From: Mark Warwick <Mark.Warwick@arun.gov.uk>
Sent: 17 February 2020 16:42
To: Lynnyrd Wolfe <Lynnyrd.Wolfe@arun.gov.uk>
Cc: Planning.Responses <Planning.Responses@arun.gov.uk>
Subject: BR/338/19/T

Planning Application Ref: BR/338/19/T

Location: 4 The Orchard Close, Bognor Regis, PO21 2PT

Description of works: Trim branches over roof to 4m clearance 1no. oak tree

Figure 2 Positions of final cuts

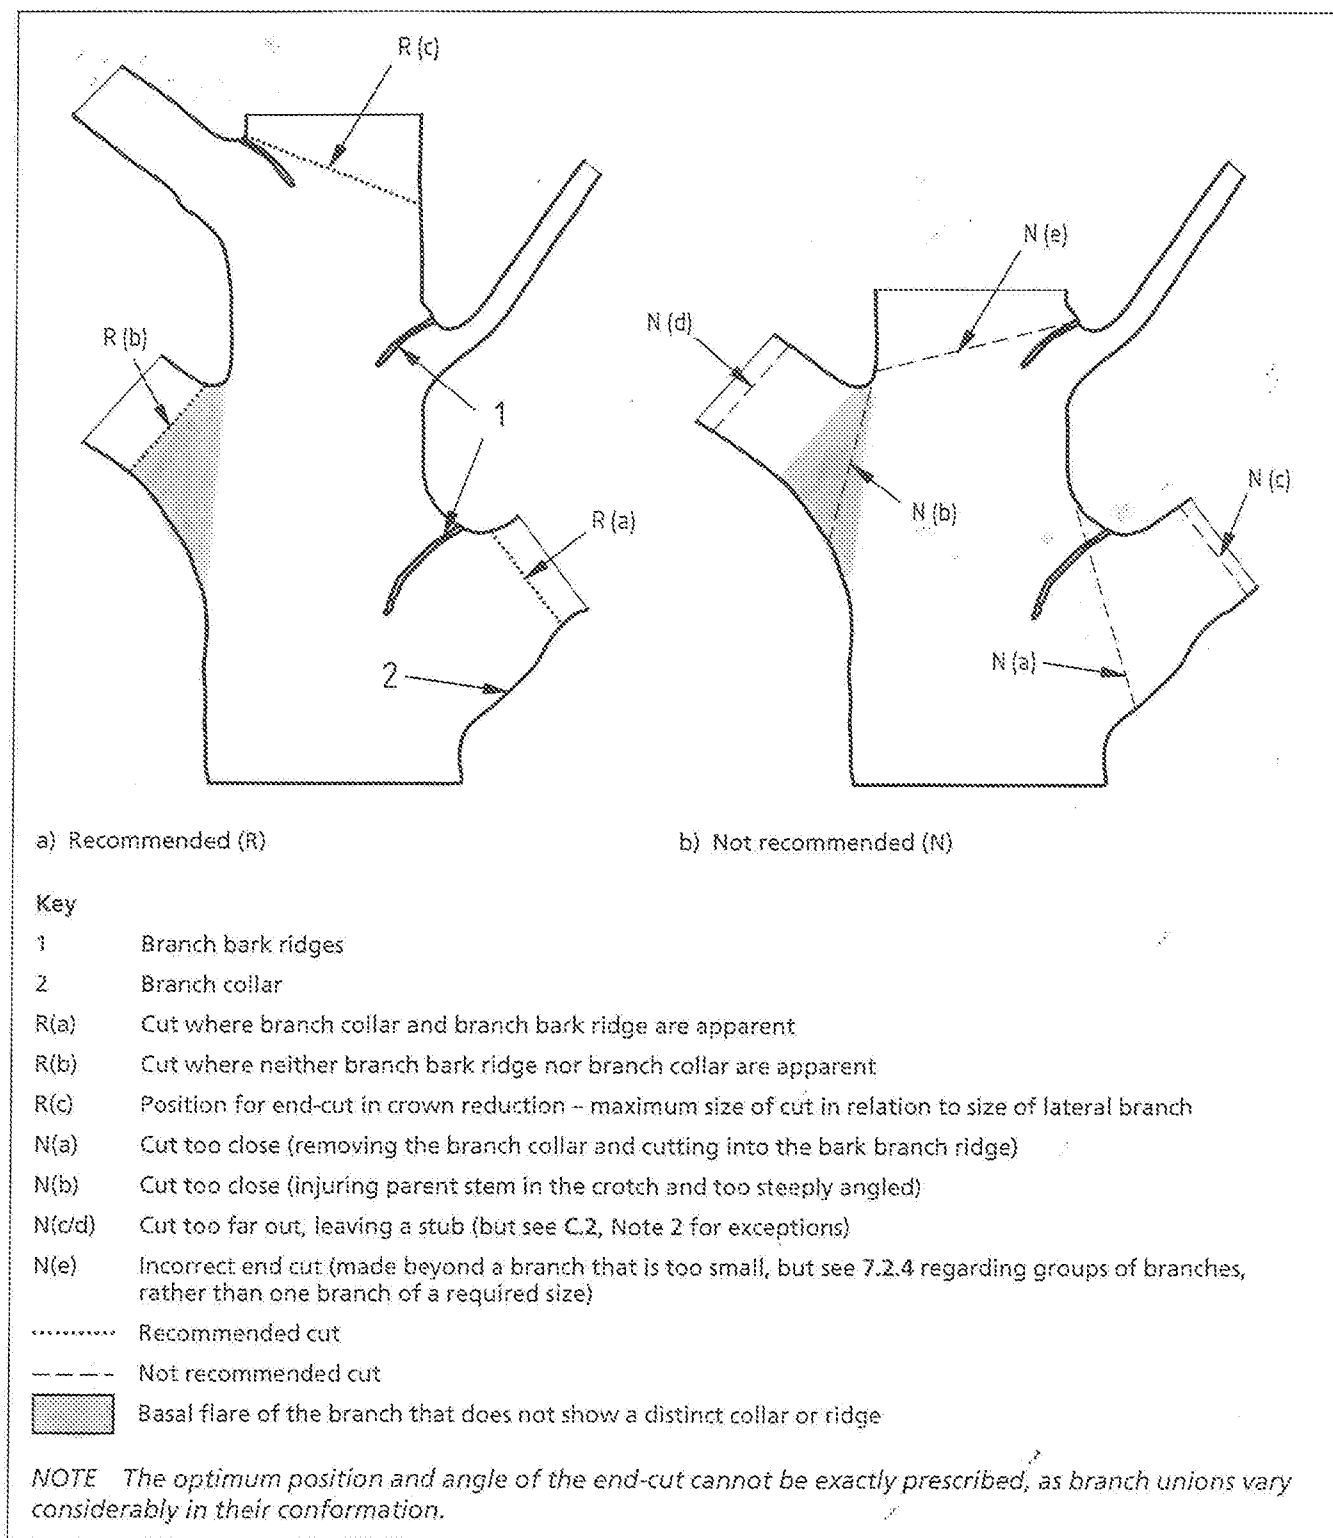
- Part a) Where whole branches are to be removed and final cuts made close to the trunk or branch union they are to be made as shown in Figure 2 of BS3998:2010
- Part b) Where branches are to be shortened back the final cuts are to be made at the correct angle shown in BS3998:2010 and adjacent to a live bud or lateral.
